**SUNDRY NOTICES AND REPORTS ON WELLS**  
**Do not use this form for proposals to drill or to re-enter an abandoned well. Use Form 3160-3 (APD) for such proposals.**

| <input checked="" type="checkbox"/> Oil Well <input type="checkbox"/> Gas Well <input type="checkbox"/> Other |   | JUPITER 30 FED COM/707H   |

Jupiter 30 Fed Com 707H API #: 30-025-52754

EOG respectfully requests an amendment to our approved APD for this well to reflect the following changes:

Revised Wellbore

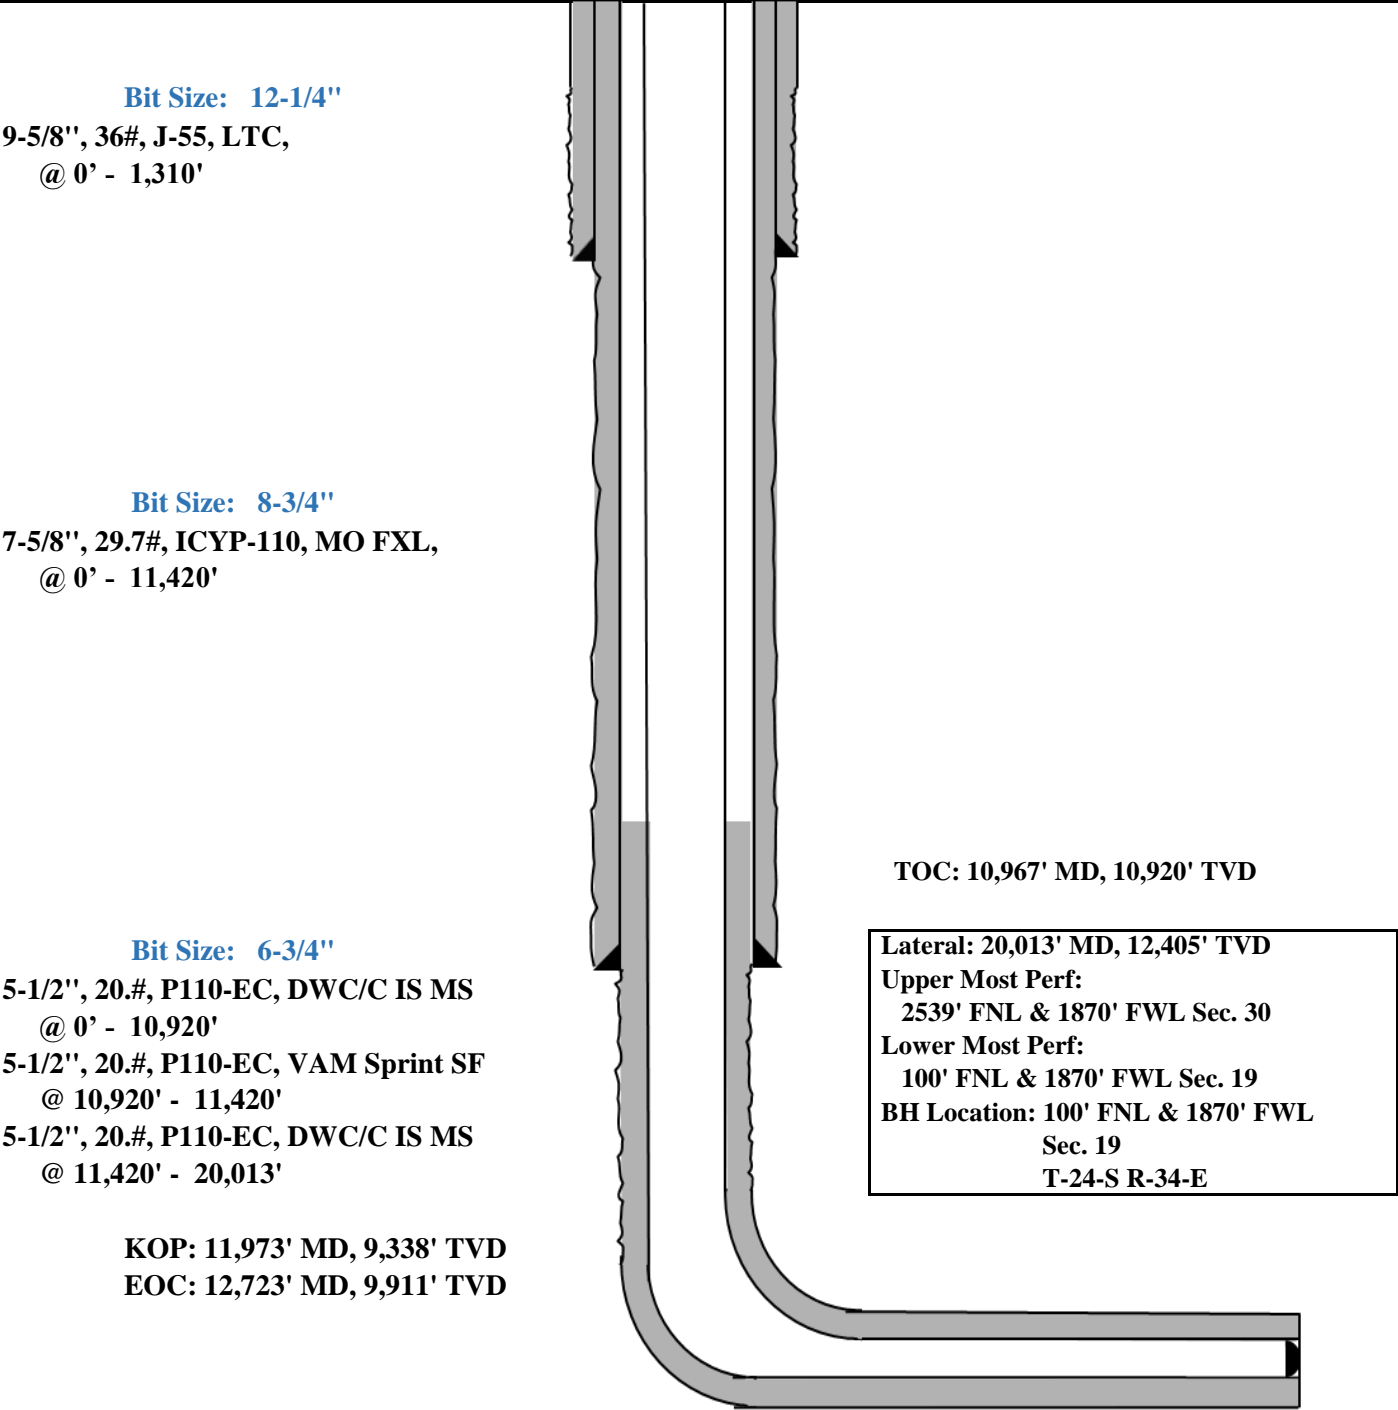
Change SHL from T-24-S, R-34-E, Sec 30, 2073' FNL, 1986' FWL, Lea Co., NM,  
to T-24-S, R-34-E, Sec 30, 2133' FNL, 1305' FWL, Lea Co., N.M.

Change BHL from T-24-S, R-34-E, Sec 19, 100' FNL, 2301' FWL, Lea Co., NM,  
to T-24-S, R-34-E, Sec 19, 100' FNL, 1870' FWL, Lea Co., N.M.

Update casing and cement program to current design.

TOC: 10,967' MD, 10,920' TVD

Lateral: 20,013' MD, 12,405' TVD  
Upper Most Perf:  
2539' FNL & 1870' FWL Sec. 30  
Lower Most Perf:  
100' FNL & 1870' FWL Sec. 19  
BH Location: 100' FNL & 1870' FWL  
Sec. 19  
T-24-S R-34-E

KOP: 11,973' MD, 9,338' TVD  
EOC: 12,723' MD, 9,911' TVD
